Development Management Sub Committee

**Application for Planning Permission 18/09696/FUL
At Former St Margaret's School, 4 East Suffolk Road,
Edinburgh
Conversion of pre-school nursery to six dwellings with car
parking, bin stores and landscaping.**

Item number	7.1
Report number	
Wards	B15 - Southside/Newington

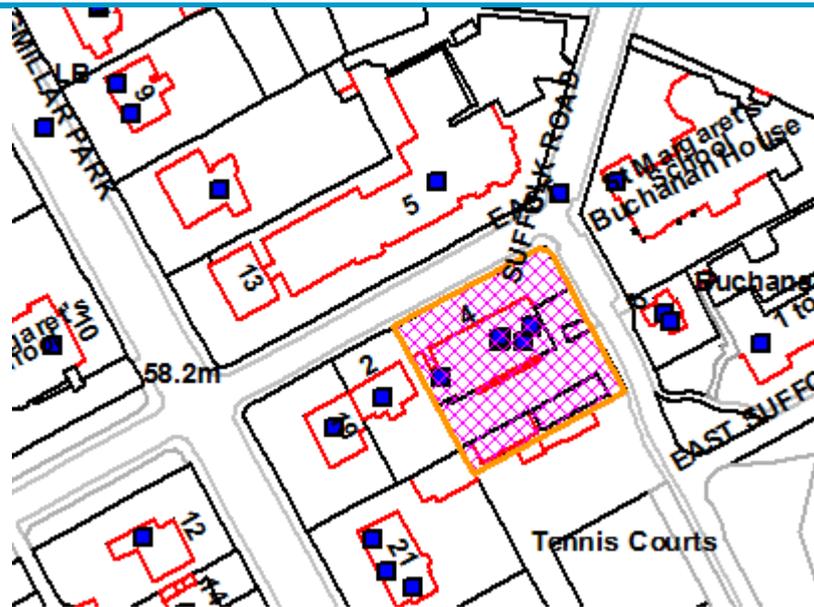
The proposed cycle parking locations require access via a number of doors and step and is not therefore not considered acceptable. The applicant should be required to revise the cycle parking provision to meet the above requirements;

2. The proposed bin location adjacent to East Suffolk Park is likely to lead to conflict with parked vehicles, including those in the disabled parking space. The proposed location should be revised.

- 1. Cycle parking to be provided in a secure and convenient location;*
- 2. Bin provision to be located so as not to interfere with the safe and convenient use of the disabled and other parking spaces;*
